AMENDMENT REPORT

Julius Avenue Data Centre

SSD-80018208

6-8 Julius Avenue, North Ryde
Lot 89 DP1082131

Figure 6: Tree Removal Schedule (Arcadia, 2025)

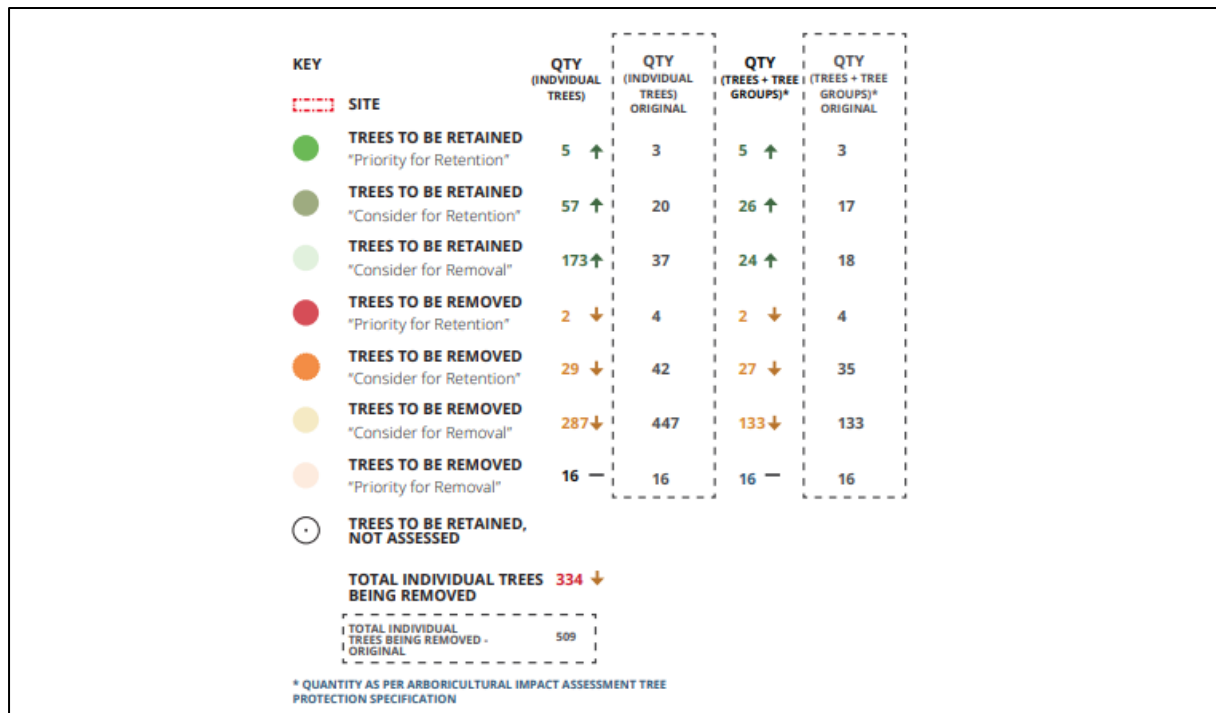
The amended development necessitates the removal of 334 trees, the vast majority of which are not mature trees and simply regrowth on the existing site cut footprint. The original proposal intended to remove 509 trees hence the amended development proposal will result in an improved outcome, with 175 fewer trees requiring removal.

Approximately 220 of the 334 trees to be removed are regrowth trees less than 20 years old located on the existing site cut.

Figure 8: Proposed Removal of Western Walking Track (Arcadia, 2025)

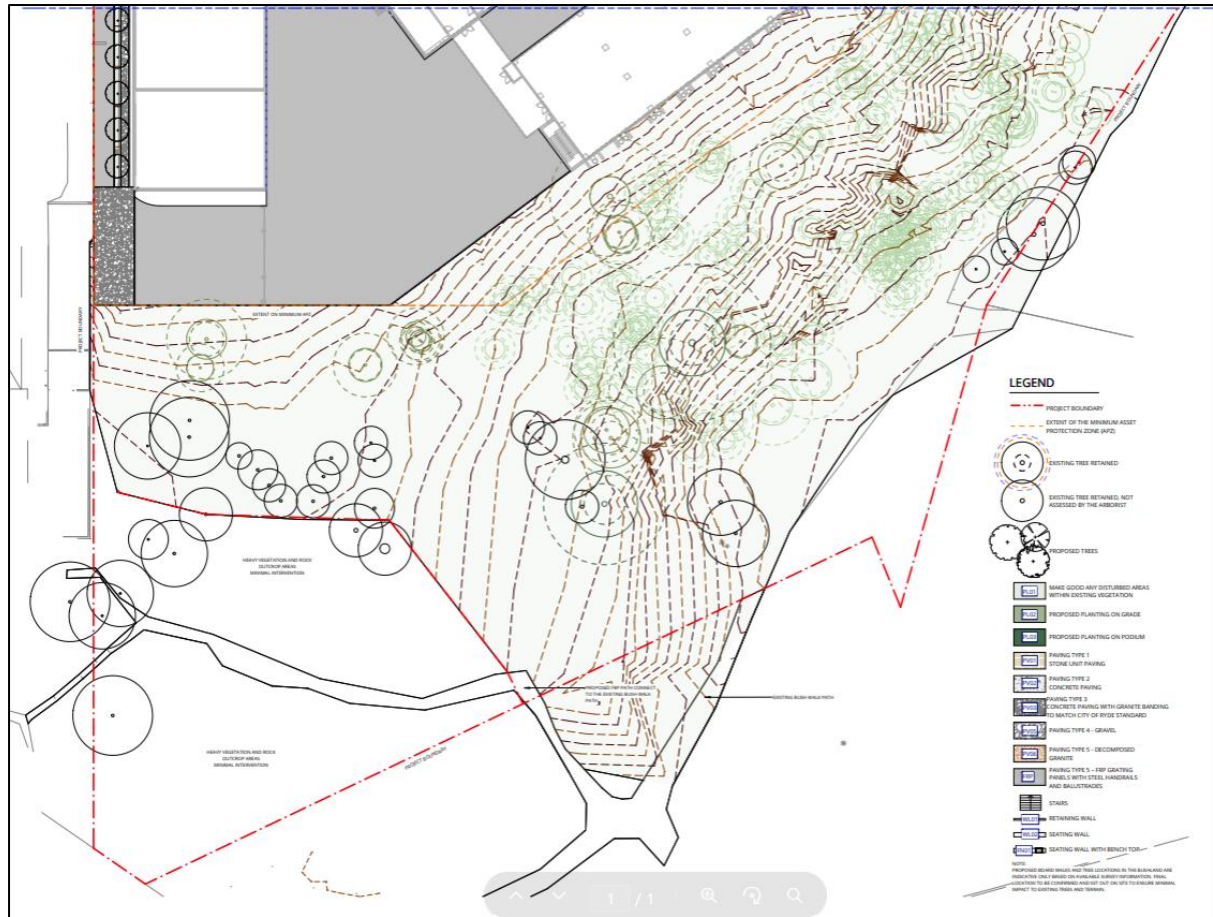
The previously proposed walking track on the western side of the subject site has been removed from the proposed development. This amendment is to avoid disturbance of existing bushland through on-site retention rather than the provision of an additional pedestrian connection. Notwithstanding, the pedestrian link path to the east of the subject site will be maintained.

TABLE 8. ARCHITECTURAL OPTIONS ANALYSIS

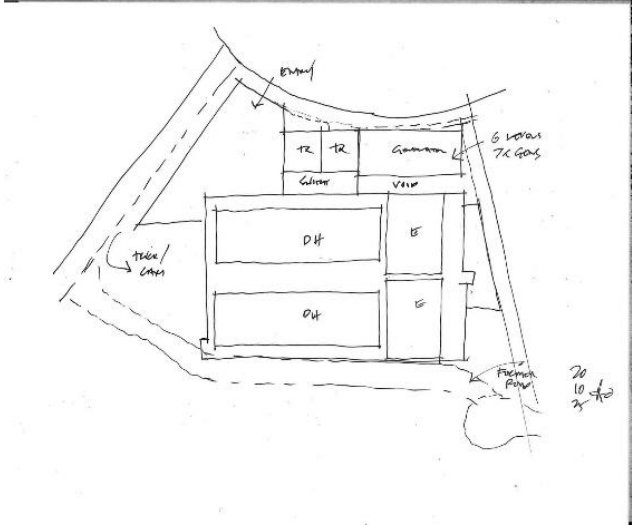
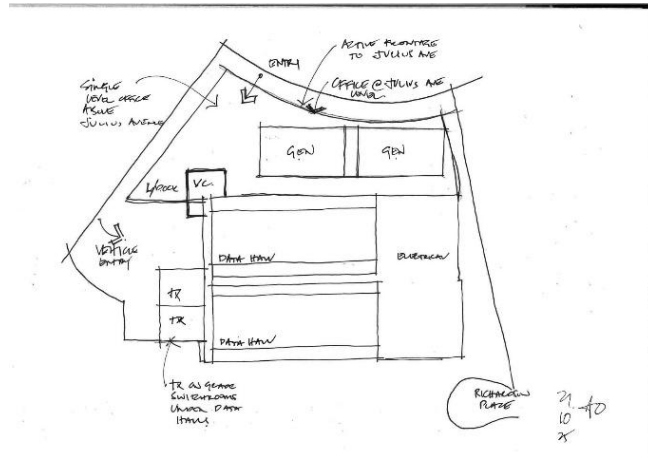
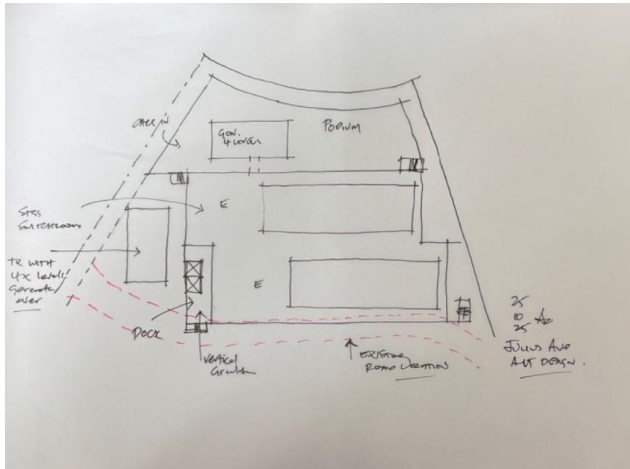
Design Stage	Comment
Initial Design (SSDA Submission) – as per EIS Submission (Figure 3)	DPHI cited the following concerns regarding the development: <ul style="list-style-type: none"> ▪ Height exceedance beyond 45m prescribed under RLEP2014; ▪ Bulk and scale of the project; ▪ Materiality and the visual impact; ▪ STSS location; ▪ Parking losses as a result of the extension of Richardson Place from the existing cul-de-sac; and ▪ Development footprint and perceived impact to neighbours and biodiversity.
Relocation of generators and transformers to the north. 	Advantages: <ul style="list-style-type: none"> ▪ Removal of generators from southern elevation. ▪ Transformer located closer to incoming feeds on Julius Avenue. Disadvantages: <ul style="list-style-type: none"> ▪ Lack of activated frontage to Julius Avenue with transformers and generators facing Julius Avenue. ▪ Generators not aligned with data hall levels. ▪ Inability to configure functional air-cooling arrangement with generators on the North side due to heights and prevailing wind direction. ▪ Clash with generator air flow and roof mounted mechanical plant. ▪ Increased bulk and scale when viewed from Julius Avenue. ▪ Unacceptable acoustic impacts to residential receivers to north-west with generators located on north side. ▪ Inferior streetscape vista from Julius Avenue with generators to north. ▪ Inability to configure materials handling access for key infrastructure elements. ▪ Inferior exhaust dispersion profile with generators to north.

- Inability to configure functional air-cooling arrangement with generators on the North side due to heights and prevailing wind direction.
- Complexity and limitations for plant installation to roof level.
- Increased bulk and scale when viewed from Julius Avenue.
- Unacceptable acoustic impacts to residential receivers to north-west with generators located on the north.
- Inferior streetscape vista from Julius Avenue with generators to north.
- Dock configuration unable to accommodate minimum vehicle swept paths.
- Inability to configure materials handling access for key infrastructure elements.
- Inferior exhaust dispersion profile with generators to north.

- Separation of Generators gantries engineering issues
- Generator over TX structural and installation challenges
- Complexity and limitations for plant installation to roof level may still require Richardson Place extension.
- Unacceptable acoustic impacts to residential receivers to north-west with generators located on North side.
- Dock configuration unable to accommodate minimum vehicle swept paths.

Figure 10: Proposed Building Footprint (Greenbox, 2026)

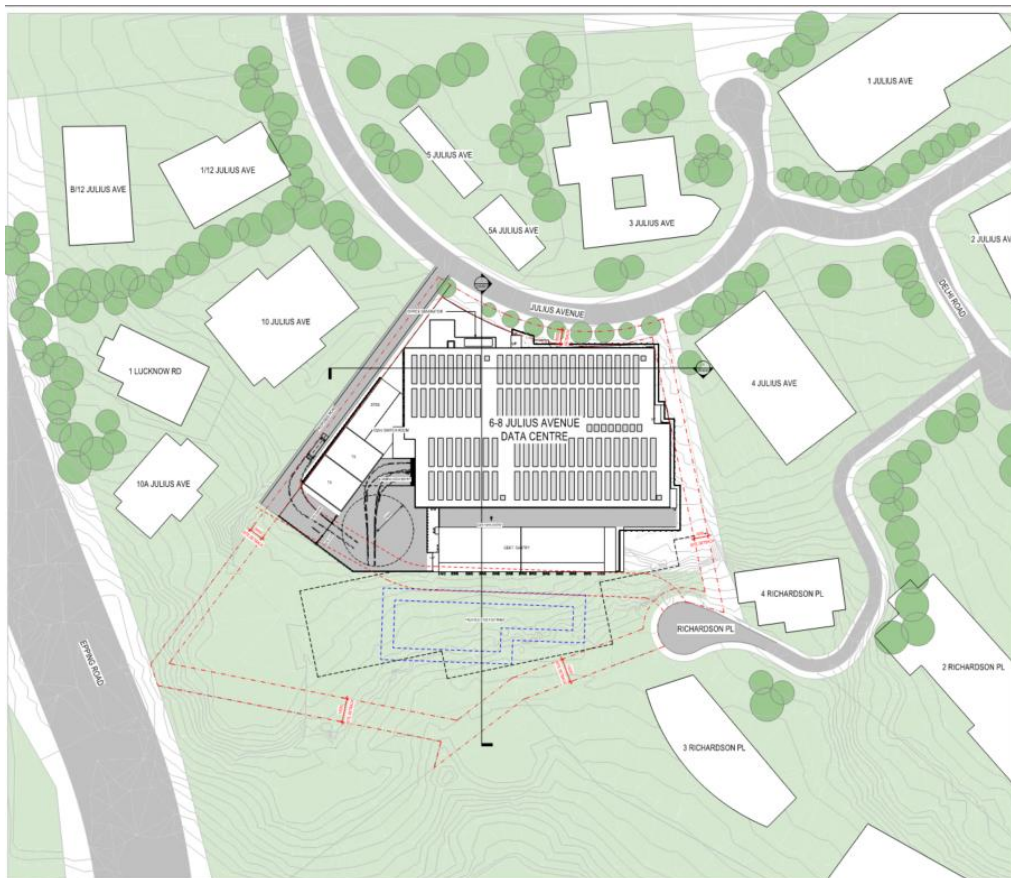
A substantial reduction in external roads, infrastructure and building area is proposed, with a decrease in FSR from 0.91:1 to 0.58:1, resulting in a materially reduced encroachment into the Landscape Setback Area, pursuant to Figure 37b of the Macquarie Park Design Guide.

The most substantial improvements are attributed to reducing the size of the electrical infrastructure and relocating it within the main building zone, along with removing the original link road from the south side of the building. The remaining encroachment into the bushland area is primarily due to the increased setbacks introduced to Julius Avenue, as well as eastern and western boundaries, which moved the data centre building to the south. The figures below show the original scheme and the now updated scheme in terms of the landscaped setback encroachment.
